BAKERSFIELD CITY SCHOOL DISTRICT
 MODERNIZATION AT CURRAN MIDDLE SCHOOL FOR:
 1116 LYNNIC WAY
 BAKERSFIELD CALIFORNIA 93309

| MARK | DATE | DESCRIPTION |
|------|----------|-------------|
| GD | 08/28/07 | ADDENDUM 1 |

FLOOR DEMO PLAN BUILDINGS A, B, & C
 SHEET IDENTIFICATION NUMBER
A-121
 SHEET 03 OF 48

A1 FLOOR/DEMO PLAN BUILDING A, B, & C
 1/8"=1'-0"

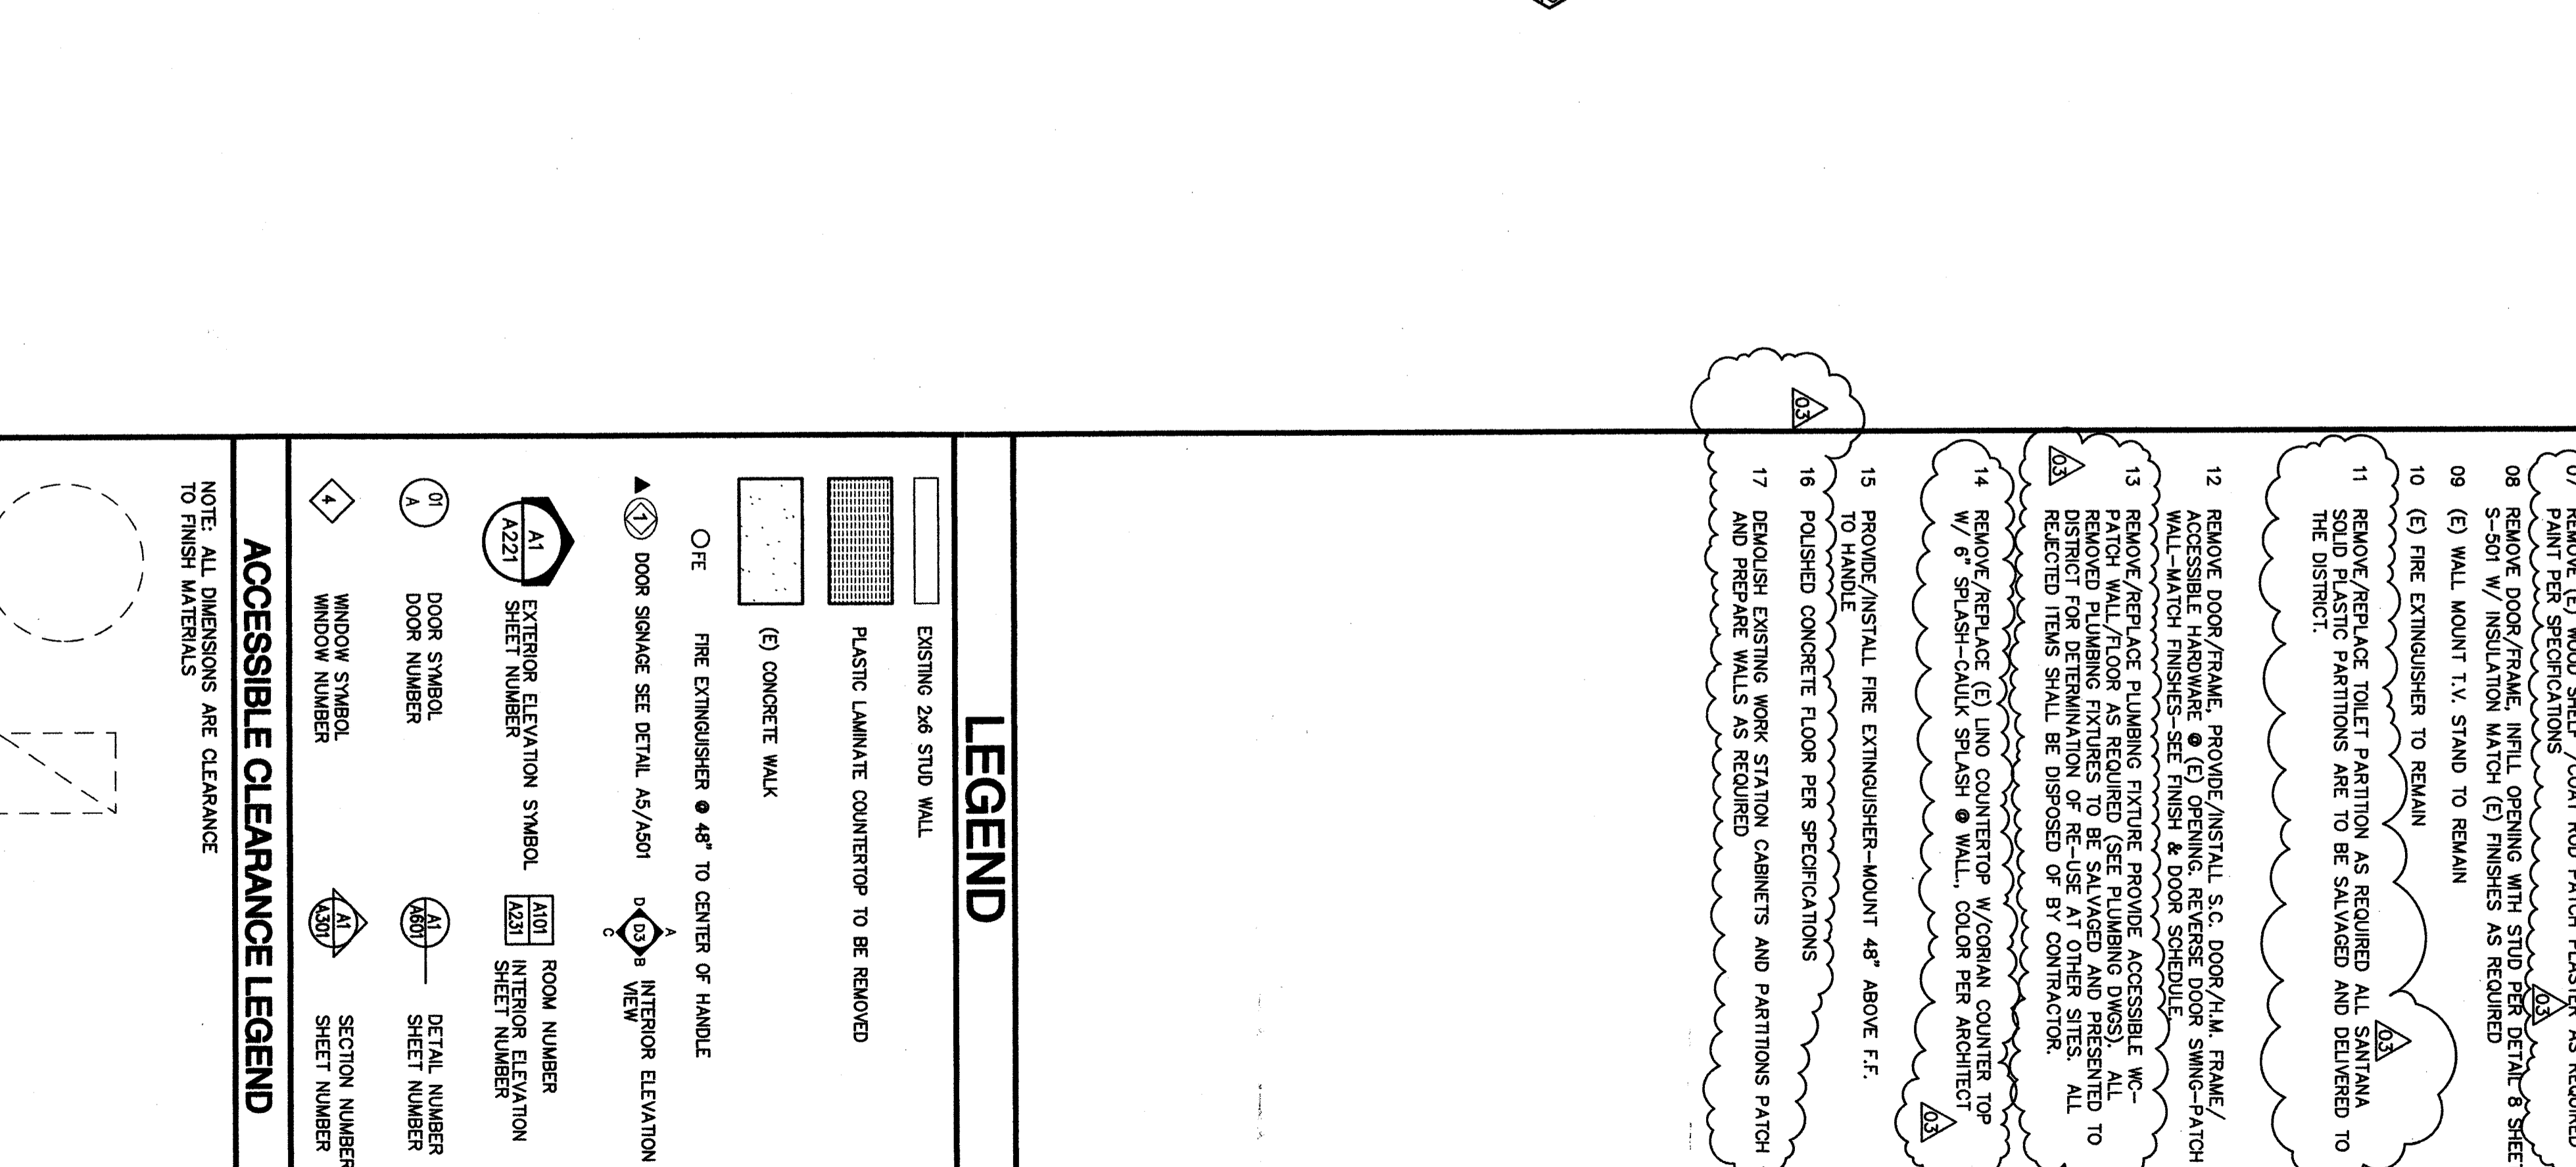
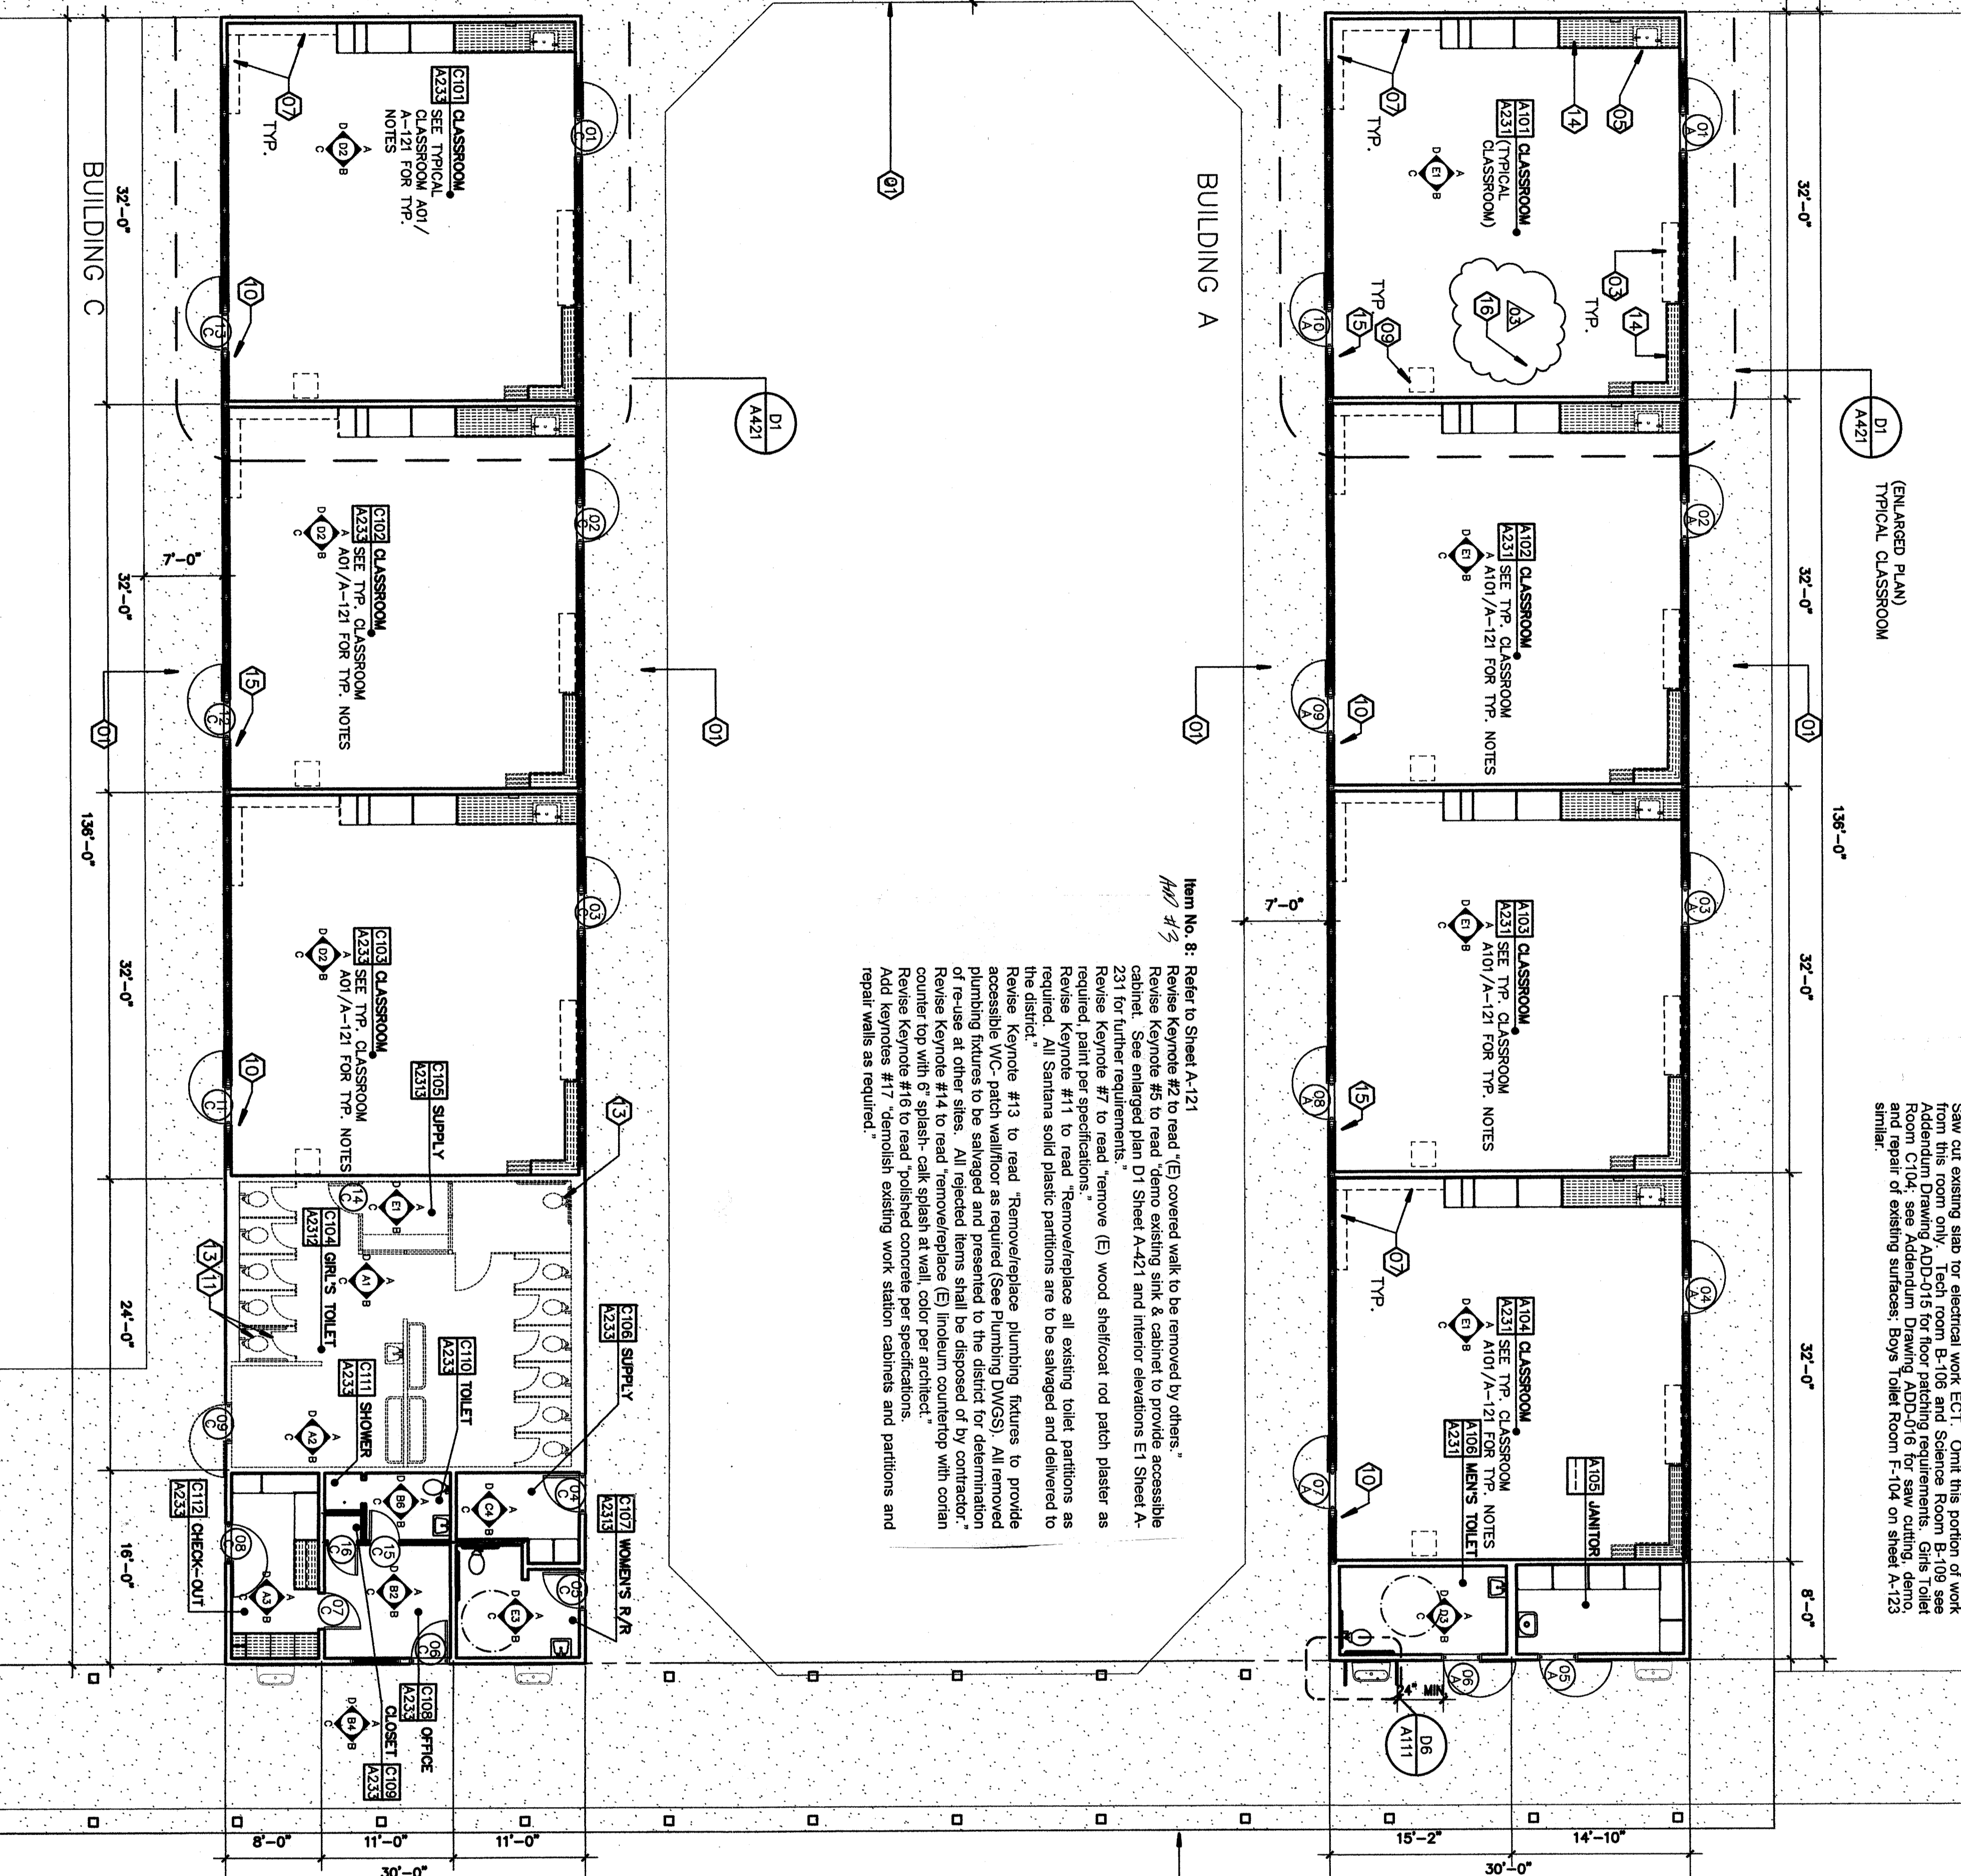
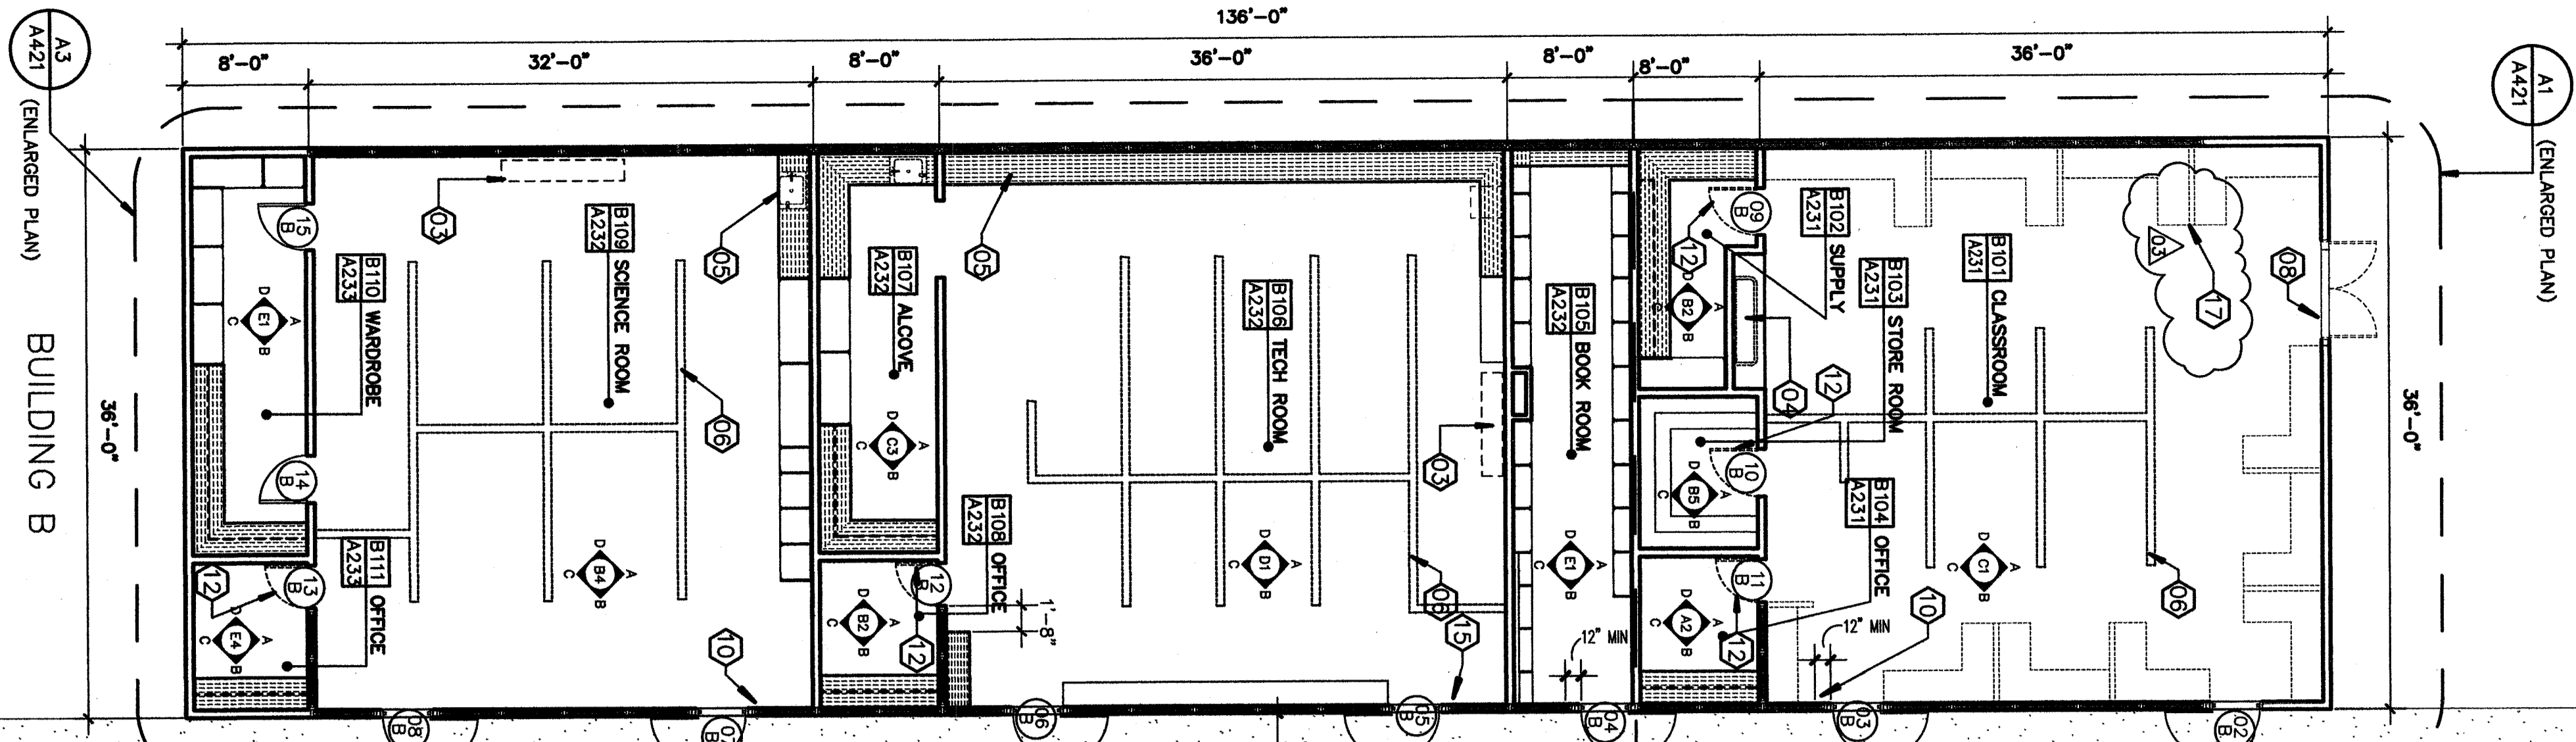
Item No. 2: Refer to Sheet A-121
 Custodian Room A-105 refer to Addendum Drawing ADD-025 for custodial room work requirements. Classroom B101, Keynote #3 and Science Room B-106 refer to Addendum Drawing ADD-015 for floor patching requirements. Classroom B-106 see Addendum Drawing ADD-015 for floor patching requirements. Girls Toilet and restrooms refer to Addendum Drawing ADD-016 for new ceiling, demo, and repair of existing structure. Boys Toilet Room F-101 see sheet A-123 similar.

Item No. 8: Refer to Sheet A-121
 Revise Keynote #2 to read "(E) covered walk to be removed by others."
 Revise Keynote #5 to read "demo existing sink & cabinet to provide accessible cabinet. See enlarged plan D1 Sheet A-421 and interior elevations E1 Sheet A-231 for further requirements."
 Revise Keynote #7 to read "remove (E) wood shelving and patch plaster as required."
 Revise Keynote #11 to read "Remove/replace all existing toilet partitions as required. All Santitas solid plastic partitions are to be salvaged and delivered to the district."
 Revise Keynote #13 to read "Remove/replace plumbing fixtures to provide plumbing fixtures to be salvaged and presented to the district for determination of re-use at other sites. All rejected items shall be disposed of by contractor."
 Revise Keynote #14 to read "Remove/replace (E) linoleum countertop with corian countertop with 6 splash-calk splash at wall, color per architect."

Revise Keynote #15 to read "demo and repair concrete per specifications and repair walls as required."
